Checkers Restaurant Site Plan No. 820180210

Staff Report Completed: 12/31/18

SECTION 1: RECOMMENDATION AND CONDITIONS

Figure 5- Front/South Elevation

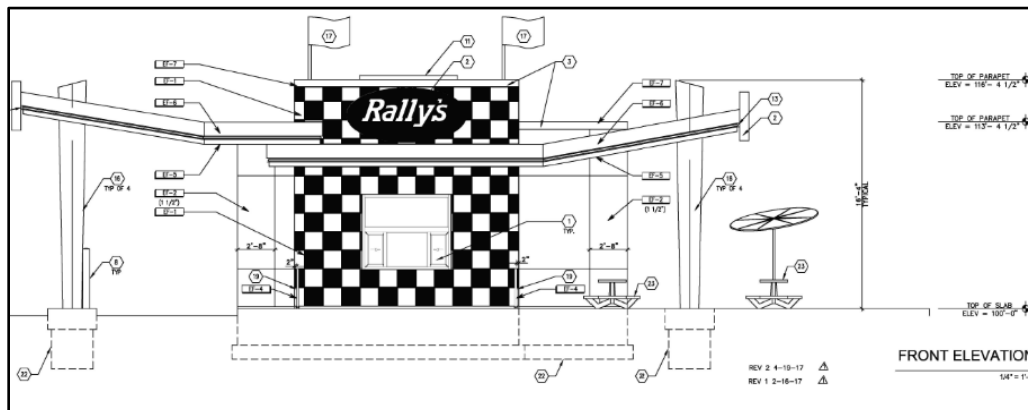
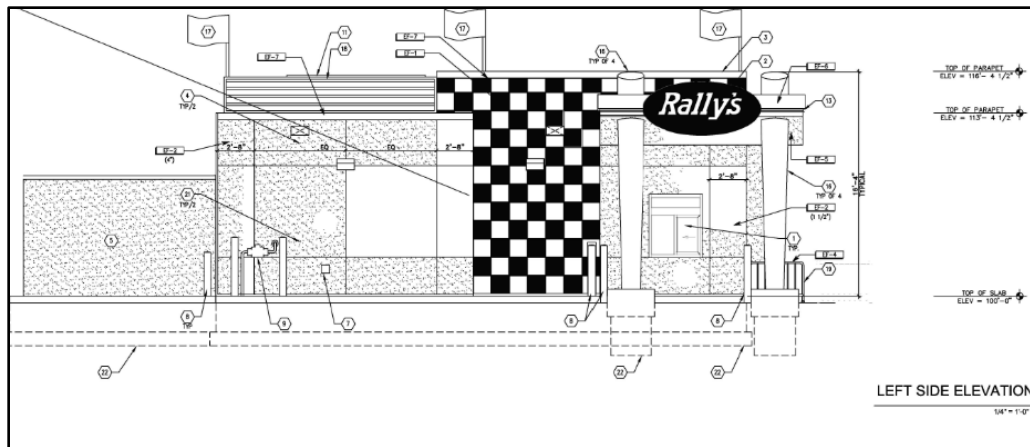
a) The exterior architectural character, proportion, materials, and articulation must be substantially similar to the schematic elevations shown on Sheet A5.1-2 of the submitted architectural drawings, as determined by M-NCPPC Staff.

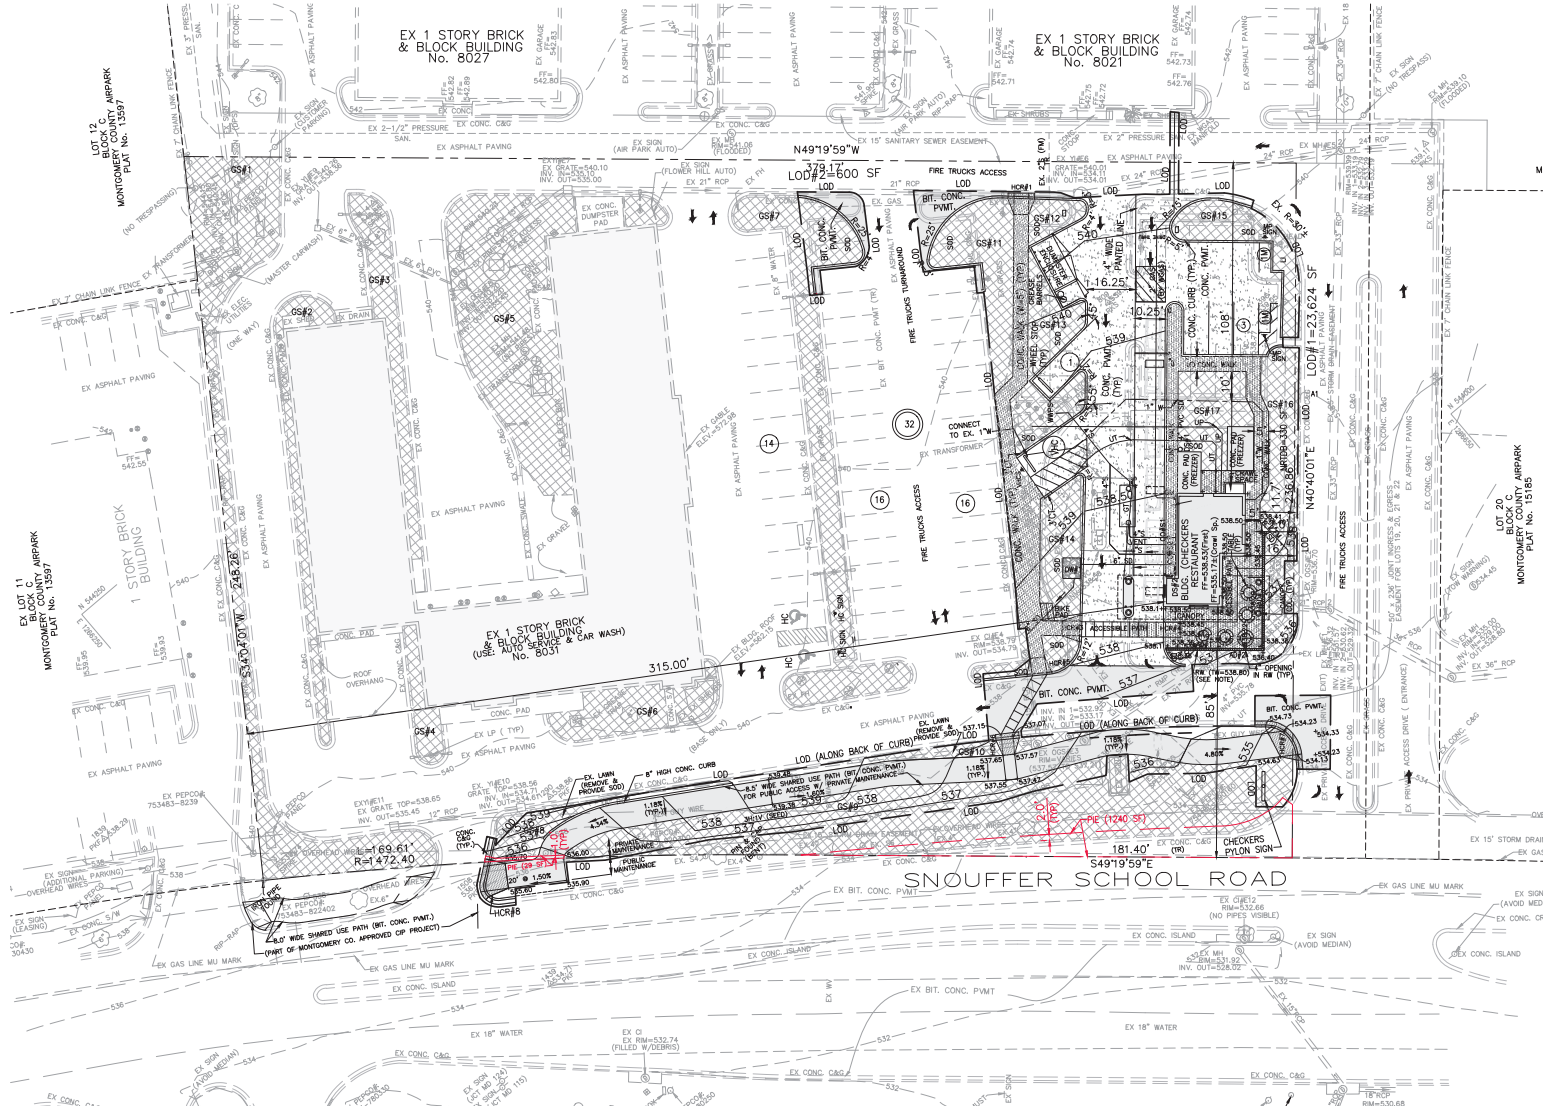
- d) Add the bike rack design to the landscape plans.
- e) Prior to approval of the Certified Site Plan, the *Nandina domestica* and *Vinca minor* must be replaced on the landscape plans with non-invasive species.

- f) Modify data table to reflect development standards approved by the Planning Board. Ensure consistency of all details and layout between Site and Landscape plans.

Two of the species proposed on the Landscape plans, *Nandina domestica* and *Vinca minor*, are listed as invasive species in the Invasive Plant Atlas of the United States. These species must be replaced with non-invasive species on applicable plan sheets before Certified Site Plan.
